Code: CEVNI EG/2014/14

Subject: Minutes of the 24th meeting of the CEVNI Expert Group

Minutes of the twenty-fourth meeting of the CEVNI Expert Group

E.6.1 Use of spuds permitted (see article 7.03)

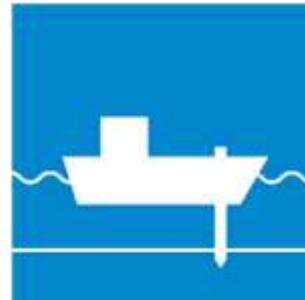
17. The Group examined the proposal by the Netherlands for inserting new provisions on the use of spuds (CEVNI EG/2014/9) and decided as follows:

(b) *Insert a new sign E.6.1 in annex 7 as follows*

4. In case this article is extended to the use of spuds, in sections where anchoring is prohibited under the provisions of paragraph 1 (a) and (b) above, vessels, assemblies of floating material and floating establishments may use spuds only in sectors marked by the sign E.6.1 (annex 7) and only on the side of the waterway on which the sign is placed.
